STUDER

Service Information

A820 MCH UP-DATE

SI 110/87 E

Werkstoff	Norm-Nr.	Oberfläche	Güte	Änderung	3
	DIN-Bez.	Ben.			1
Abmessung					
Zugehörige Unterlagen	PL, LL	Freissolteranz	Maßstab	8.9.87	A.Ho
		+	2:1	Datum	Gez. Gepr. Ges. Index
Ersatz für		Ersetzt durch		Kopie für	
STUDER REGENSDORF ZÜRICH		BASIS BOARD TAPE DECK MCH		1.820.704-81

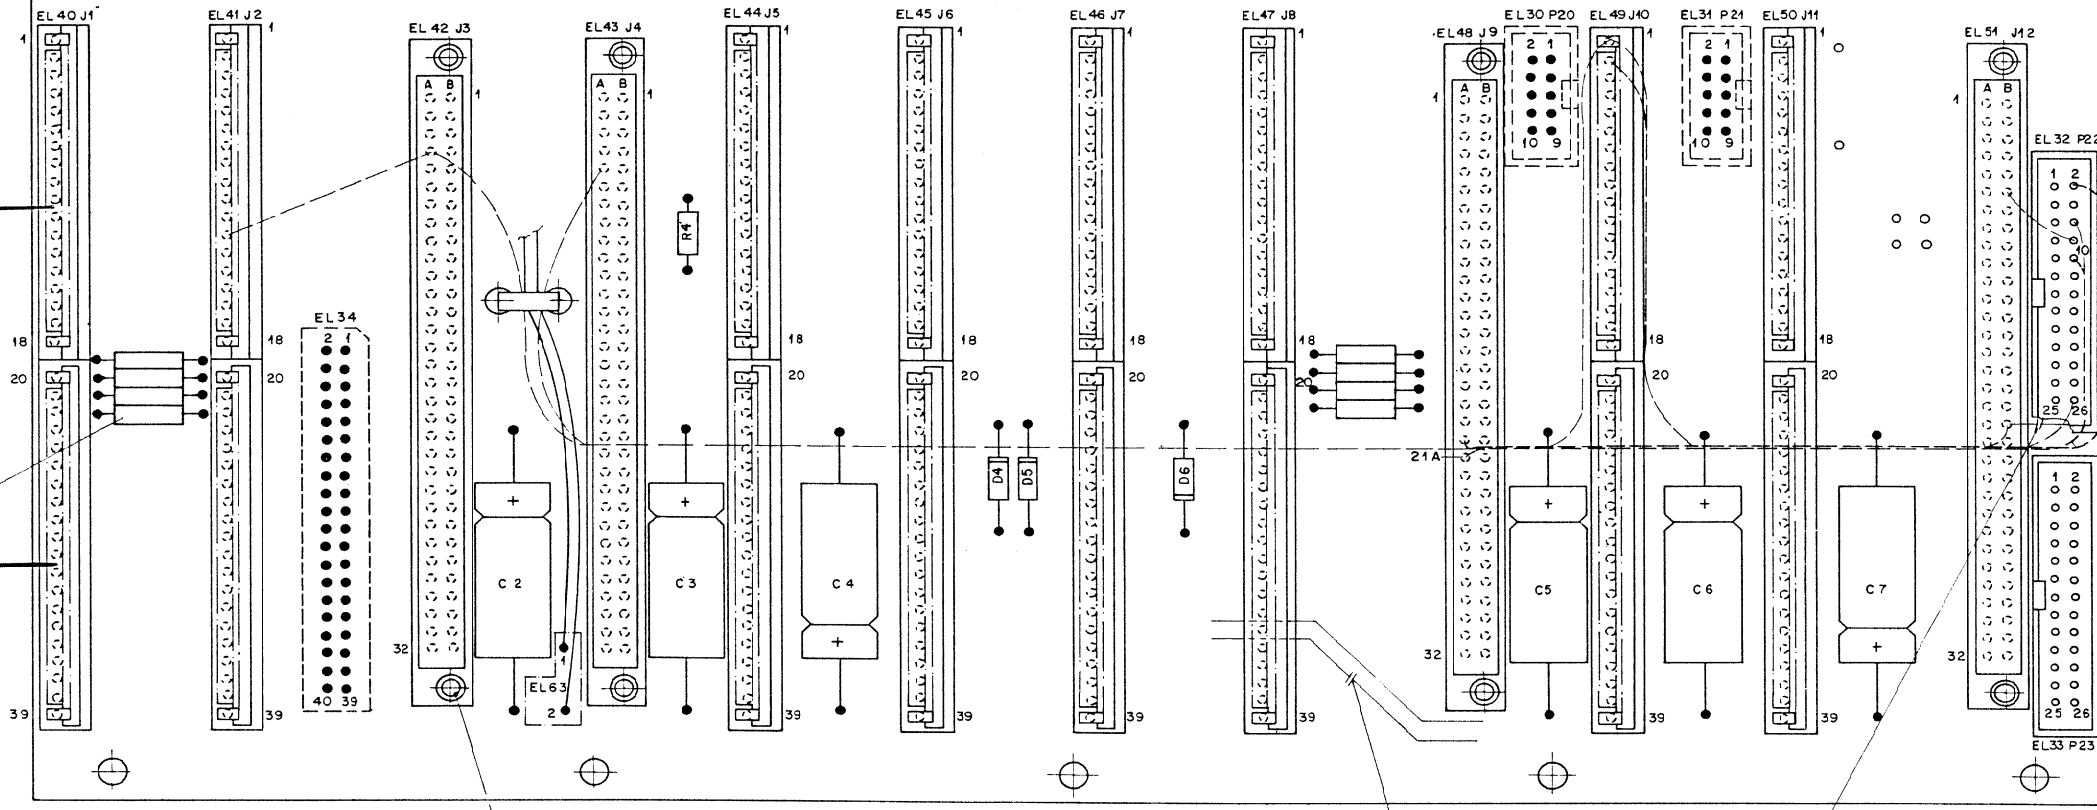
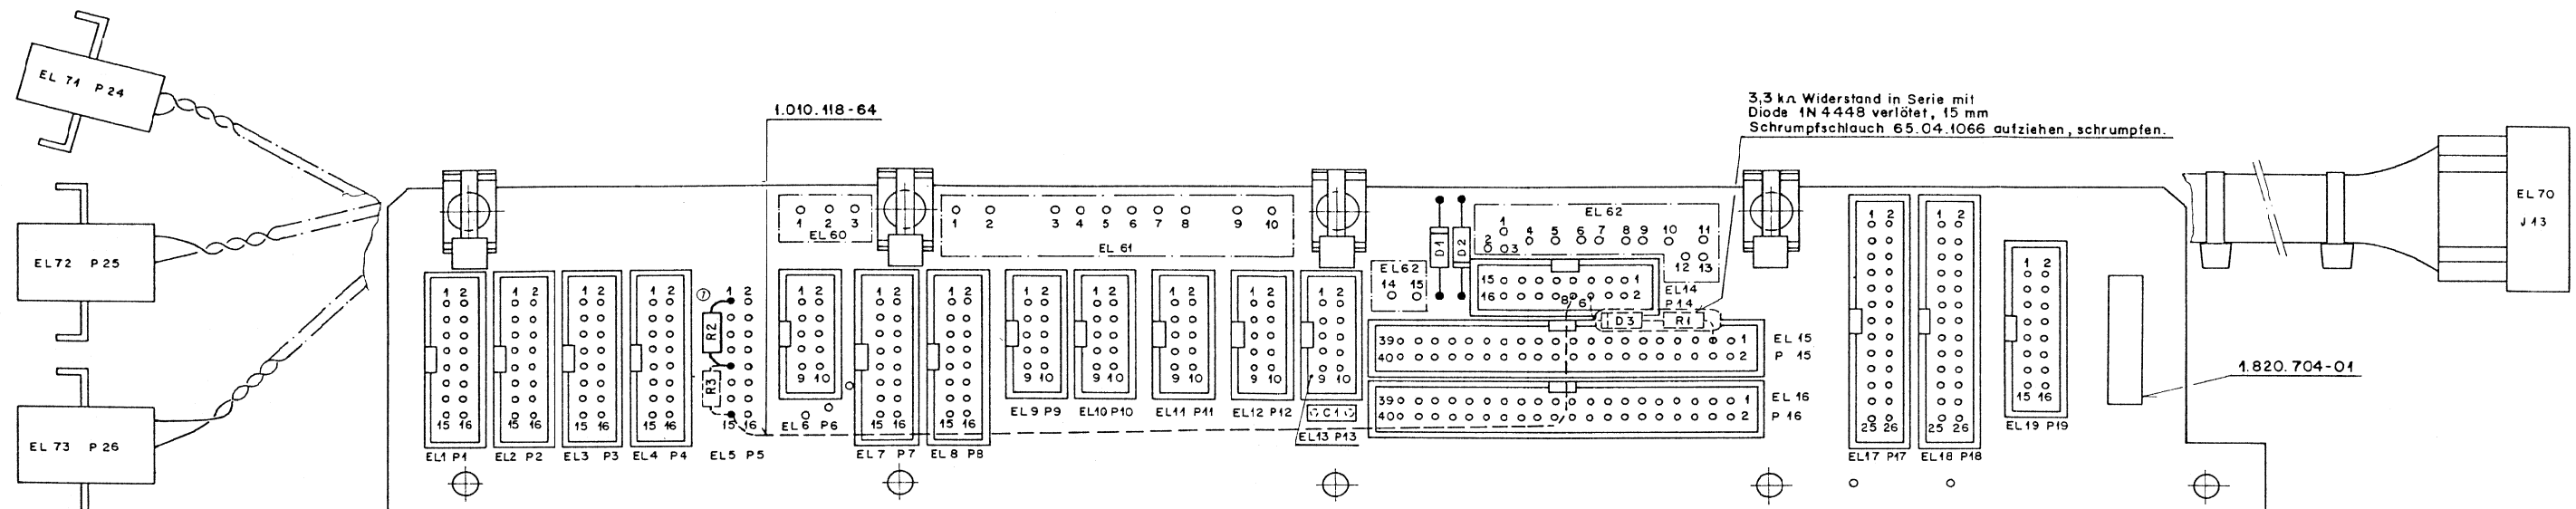
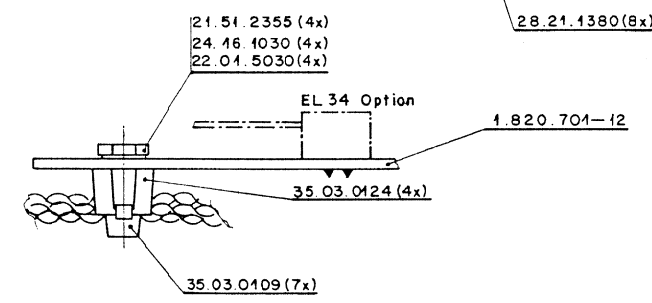
Leiterbahn auf Bestückungsseite unterbrochen

Leiterbahn Lötseite unterbrochen
(Verbindung aufgehoben;
EL 51 Pin 19 B zu EL 32 Pin 16)

Cut track on soldering side between:
- EL 51 Pin 19 B and EL 32, Pin 16

- Unplug all PCB's , flat-ribbon cables and remove Basis Board from the metall-cage. It is necessary to carry out the following modifications in the machine itself (Basis Board is still connected with the rest of the machine with some wires).
- Install wirebridges:
 - 1.010.109.64 from EL41,Pin 12 to EL42,Pin 4A
 - 1.010.130.64 from EL42,Pin 4A to EL51,Pin 19B
 - 1.010.130.64 from EL43,Pin 5A to EL49,Pin 1
 - 1.010.120.64 from EL49,Pin 1 to EL32,Pin 6
 - 1.010.117.64 from EL49,Pin 2 to EL32,Pin 26
 - 1.010.107.64 from EL51,Pin 6B to EL32,Pin 8
- Attach wirebridges to the soldering-side with adhesive-tape.
- Cut track on soldering-side marked with "II" between EL51,Pin 19B and EL32,Pin 16.
- Attach index label .81
- See drawing 1.820.704.81

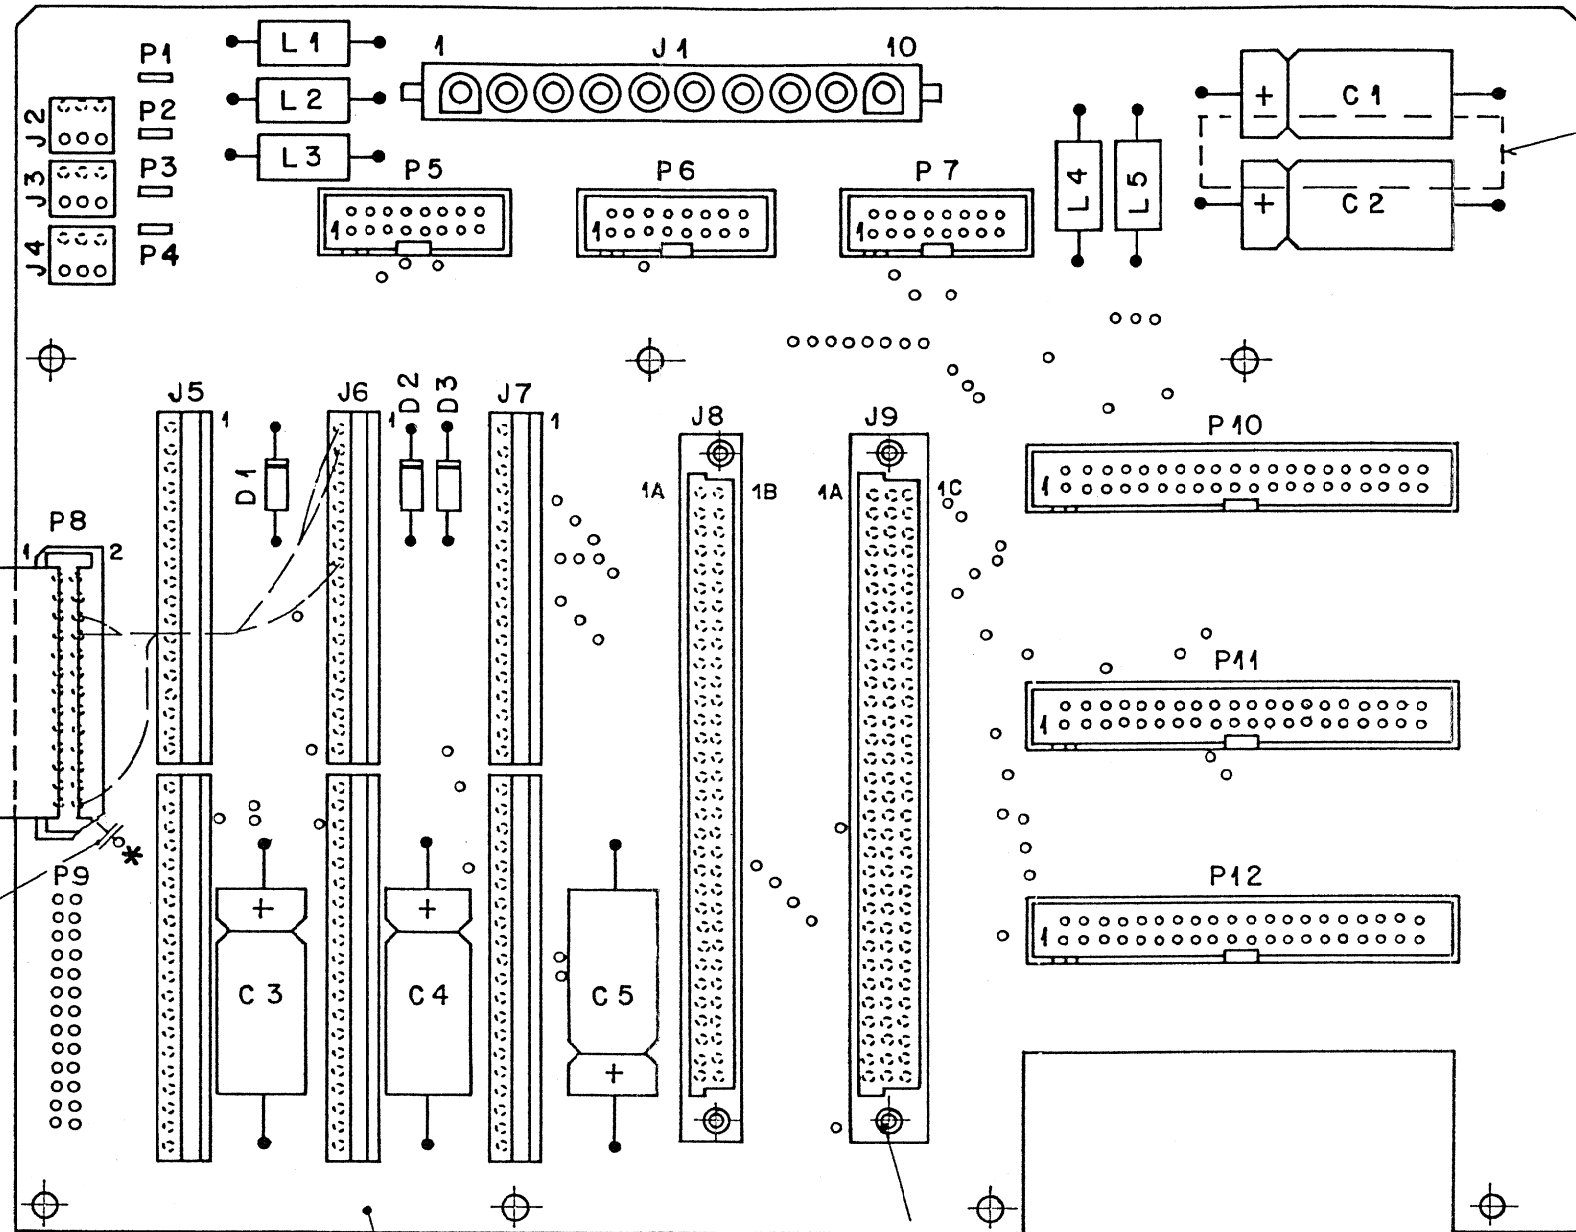
Leiterbahn BS
unterbrochen

Cut track
on component side

In P10, P11 und P12 je 1Stk
Flachkabel 1.022.740-02 eingesteckt

- Unplug all PCB's, flat-ribbon cables and remove Basis Board from the metall-cage.
- Install 3 wirebridges 1.010.111-64 on the soldering-side between: P8,Pin6 to J6,Pin1
P8,Pin8 to J6,Pin2
P8,Pin26 to J6,Pin8
- Install 1 wirebridge 1.010.107-64 on the soldering-side between: P8,Pin16 and the soldering-pad markes with "*".
- Attach wirebridges to the soldering-side with adhesive-tape.
- Cut track on the component-side marked with "II", see also drawing 1.820.702.81.
- Attach index label .81

Audio Alignment Keyboard 1.820.707.00

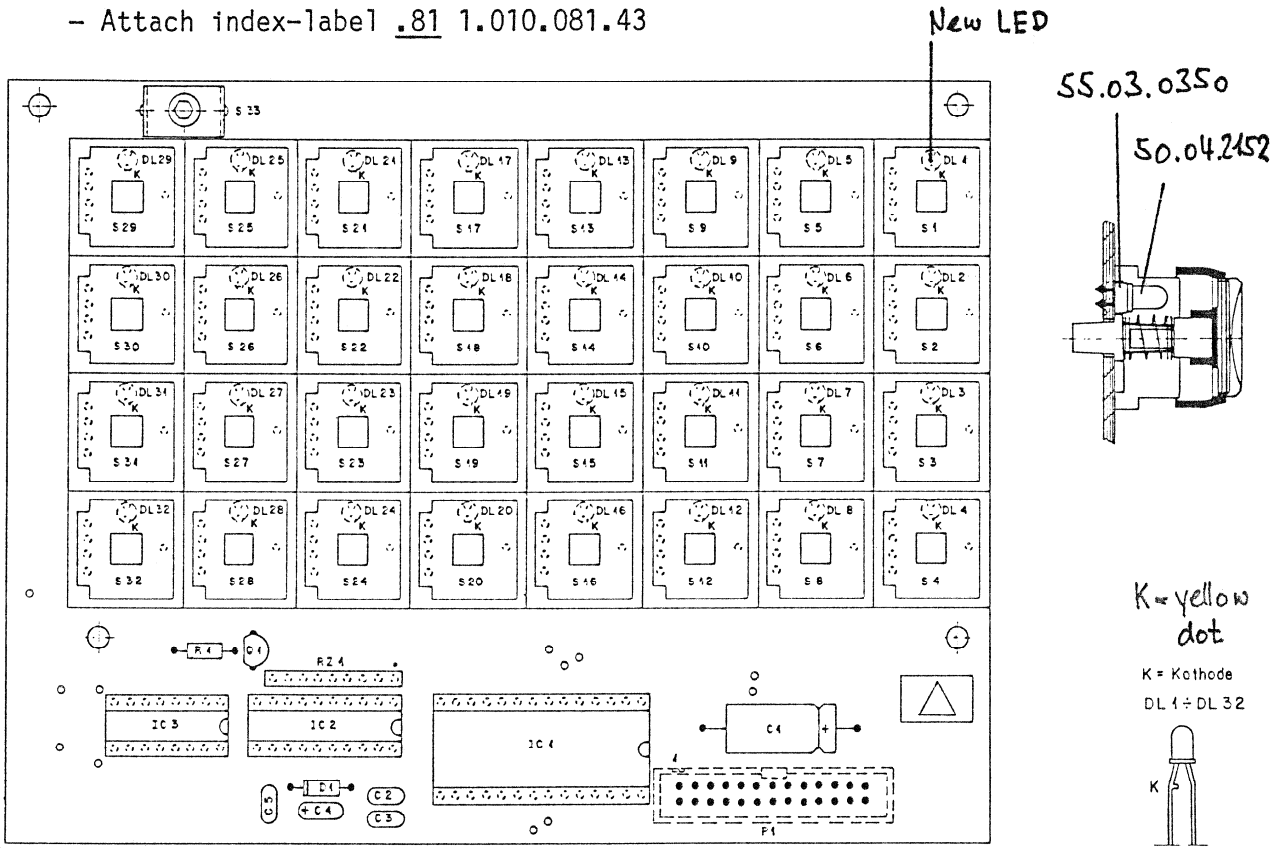
- Install one additional LED 50.04.2152 in the top right-hand corner for the push-button "NRS-ALIGN". Put a distance-piece 55.03.0350 between LED and PCB.
- Remove old labels by attaching a piece of adhesive-tape to the inlay-label and pull the inlay-label away.
- Install new labels: NRS-ALIGN, UNCAL-MODE, MANUAL-ALIGN, AUTO-ALIGN. Use in position "NRS-ALIGN" the new inlay-label white 55.03.0384 with cut-out for the LED
- Attach index-label .81 1.010.081.43

Cover Tape Tension Sensor 1.820.116.01 1", 1.820.114.03 2"

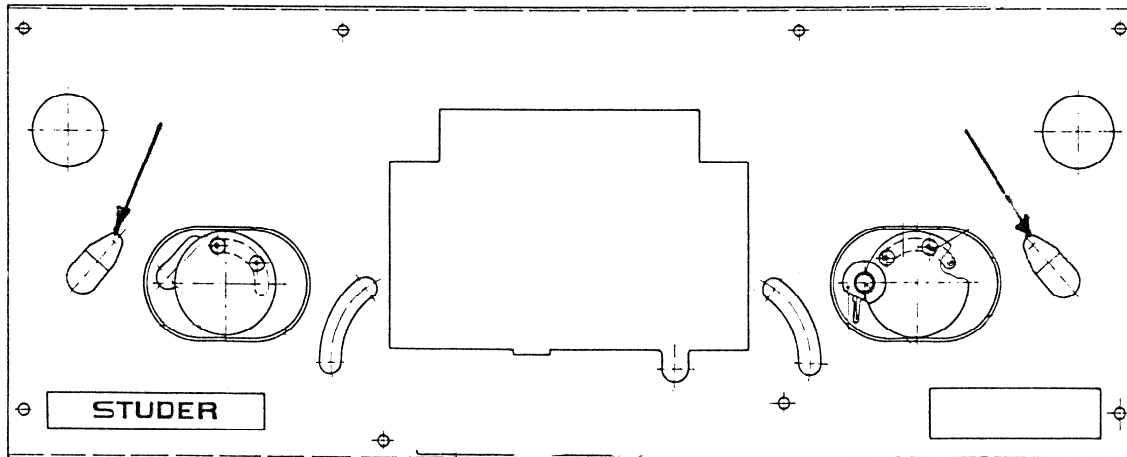
- The modified covers for the tape tension sensor have a deeper cut-out which gives the tape tension roller more space to deflect (approx. 3mm).
- Replace existing covers by the new type of covers.
